HISTORIC AND DESIGN REVIEW COMMISSION

HDRC CASE NO: 2018-446
ADDRESS: 925 BURLESON ST
LEGAL DESCRIPTION: NCB 1302 BLK 3 LOT 18
ZONING: R-5, H
CITY COUNCIL DIST.: 2
DISTRICT: Dignowity Hill Historic District
APPLICANT: Mario Herrera
OWNER: Chris Lee
TYPE OF WORK: Rehabilitation, construction of a rear addition, exterior modifications
APPLICATION RECEIVED: August 31, 2018
60-DAY REVIEW: October 30, 2018
REQUEST:

The applicant is requesting a Certificate of Appropriateness for approval to:

REVISED FLOOR PLAN
SCALE: 1/4" = 1'-0"

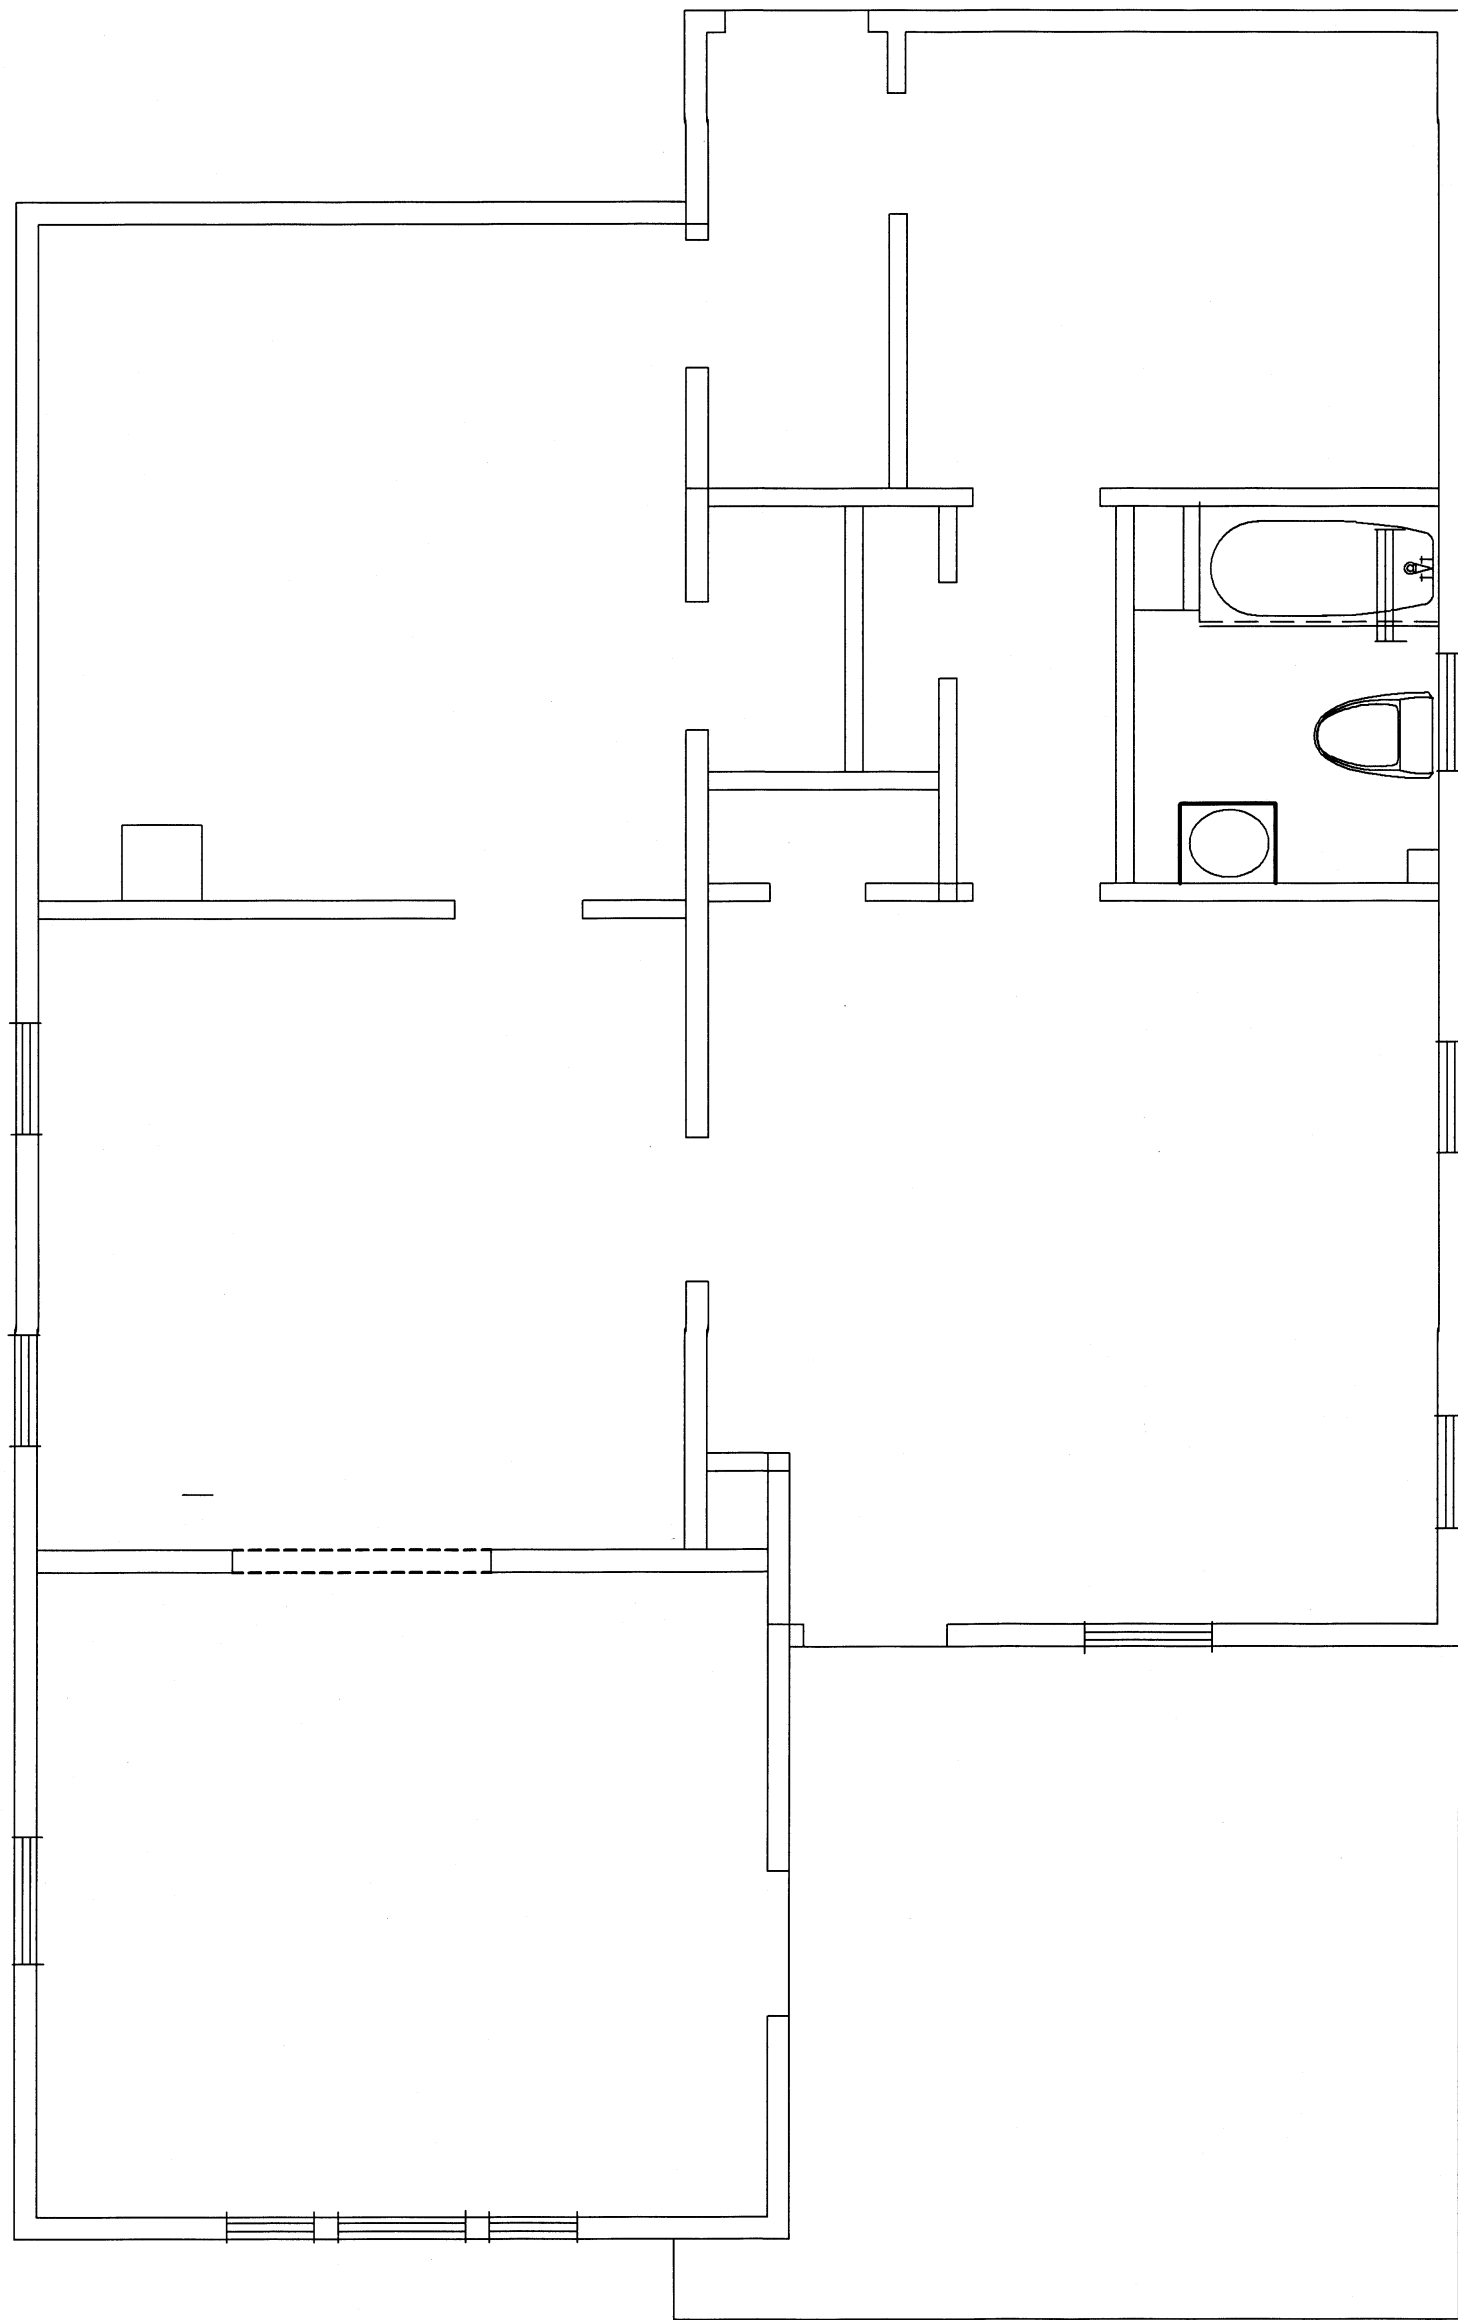
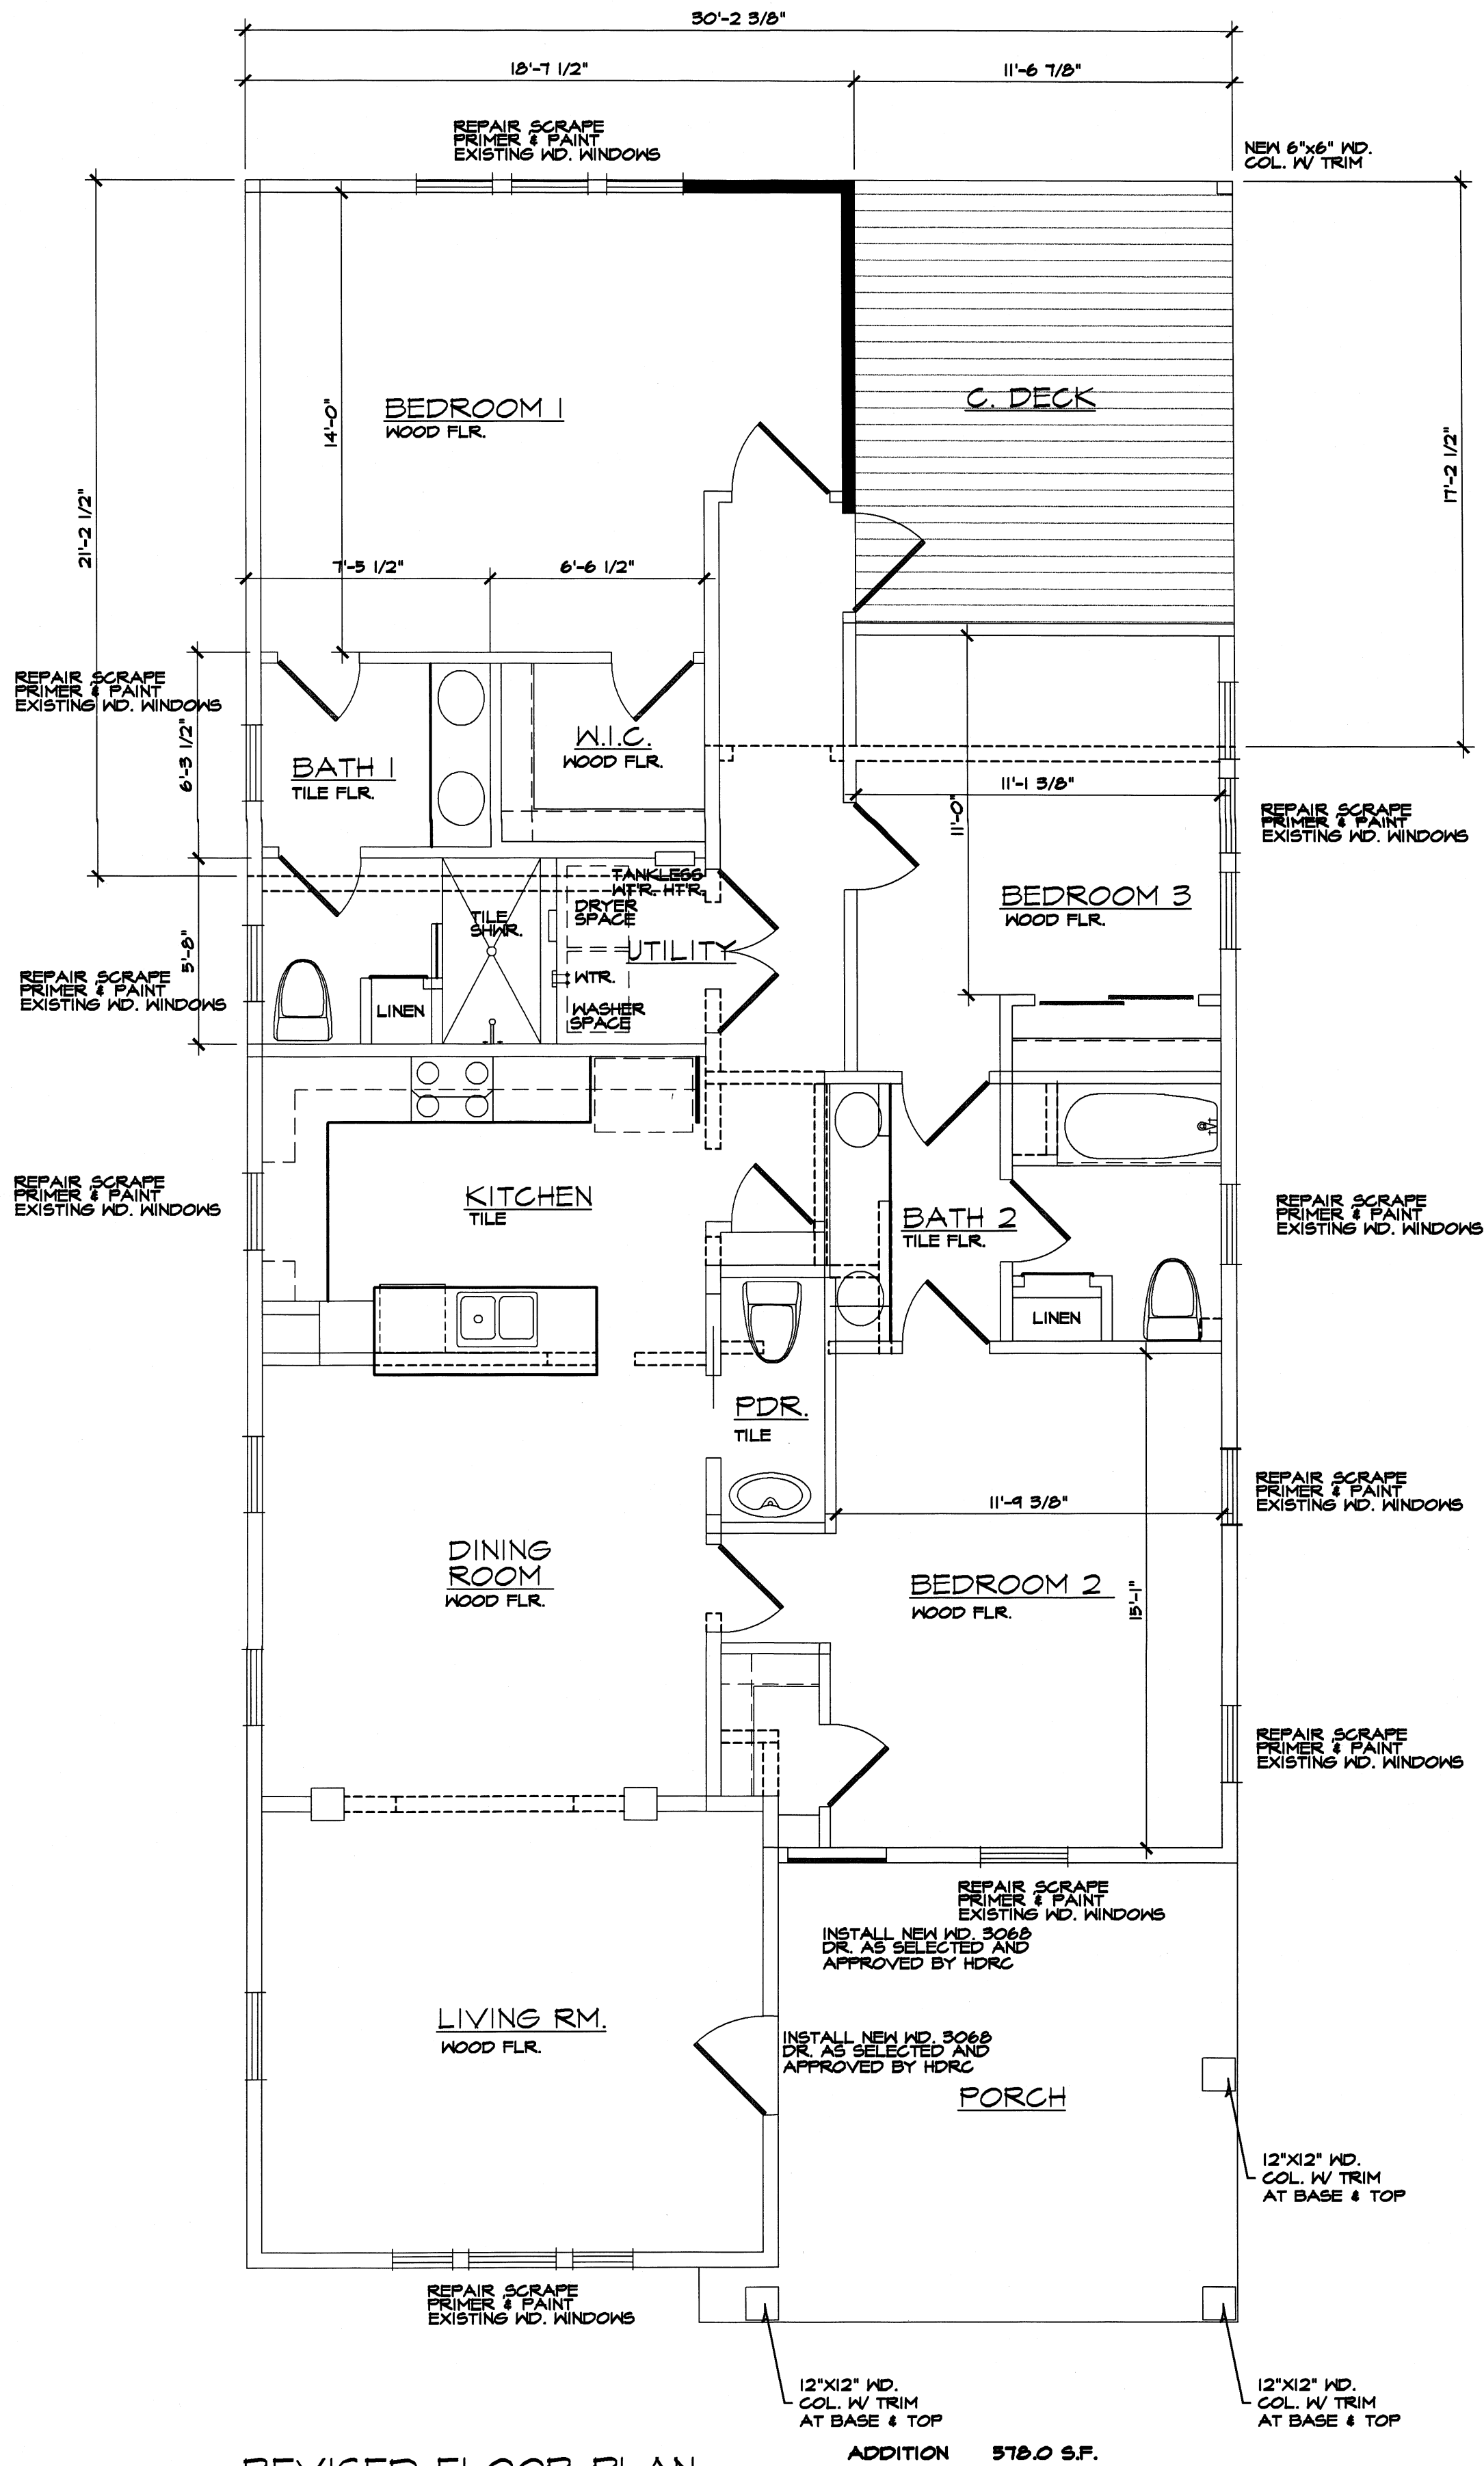
- e. REAR ADDITION – At the rear of the historic structure, the applicant has proposed to construct a rear addition of approximately 580 square feet. The existing rear addition will be maintained.

impact from the public right of way, should be designed to be in keeping with the historic context of the block, should utilize a similar roof form and should feature a transition between the old and the new. The applicant has proposed for the addition to feature an inset on the east facade, similarly mirroring that of the front porch condition. The applicant has proposed for the historic structure to feature a matching ridge line and has proposed to install a vertical trim piece on the west façade. Given the proposed inset porch on the addition, staff finds the use of a matching ridgeline to be appropriate.

- h. TRANSITIONS – As noted in finding e, the applicant has proposed for the addition to feature an inset of approximately eleven (11) feet front the east wall plane of the existing structure; staff finds this to be appropriate. On the west façade, the applicant has proposed to install a vertical trim piece to separate the existing from the proposed. While a subordinate ridge line would further differentiate the addition from the existing structure, staff finds the proposed inset facing the right of way is sufficient.

- j. ARCHITECTURAL DETAILS – Generally, staff finds the proposed architectural details to be appropriate; however, staff finds that additional fenestration should be added to the addition so that the addition does not feature a continuous wall plane facing N Palmetto. Staff suggests the applicant use the existing, rear facing windows that will be removed from the existing addition.

- 4. Staff recommends approval of item #4, the construction of a rear addition based on findings e through j with the following stipulations:
 - i. That wood or aluminum clad wood windows should be installed that feature meeting rails that are no taller than 1.25” and stiles no wider than 2.25”. White manufacturer’s color is not allowed, and color selection must be presented to staff. There should be a minimum of two inches in depth between the front face of the window trim and the front face of the top window sash. This must be accomplished by

- ii. That the proposed roof feature panels that are 18 to 21 inches in width, seams that are 1 to 2 inches in height, a crimped ridge seam and a standard galvalume finish. A ridge cap is not to be installed.
- iii. That full height windows be added to the proposed addition's N Palmetto façade to further separate the wall plane.
